Vogtle Electric Generating Plant- Units 1&2  
Systematic Risk-Informed Assessment of Debris Technical Report SNC Response to NRC  
Request for Additional Information (RAIs #4-10)

**Vogtle Electric Generating Plant Unit 1 and 2  
Systematic Risk-Informed Assessment of Debris Technical Report SNC Response to  
NRC Request for Additional Information (RAIs #4-10)**

**SNC Response to NRC Request for Additional Information (RAIs) NON-PROPRIETARY  
VERSION**

Figure 8-7: Best Estimate and Design Basis Containment Temperature Profiles

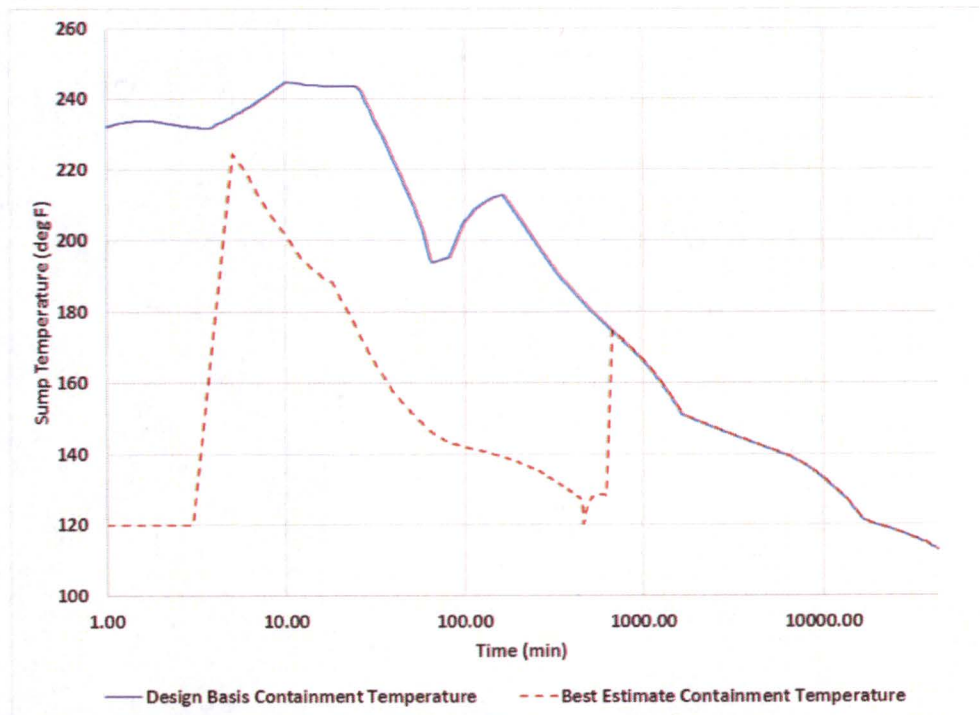
Please explain how the under prediction of aluminum release during some of the autoclave tests is being considered in the VEGP chemical effects methodology

In Case 1, the base VEGP NARWHAL model was modified with a combination of conservative chemical models and best estimate conditions. The following four changes were made:

4. The best estimate containment and sump temperature profiles for a double ended guillotine break of the hot leg developed by Texas A&M University was used. The best estimate containment and sump temperature profiles are compared with the design basis temperature profiles used in the base case in Figures 8-7 and 8-8. Note that the Texas A&M University temperature profiles were only calculated to 620 minutes post-LOCA, and the design basis temperature profiles were used for the remainder of the Case 1 temperature profiles.

The  $\Delta$ CDF was reduced from 2.47E-08 to 1.43E-08 by this combination of the conservative chemical models and best estimate conditions.
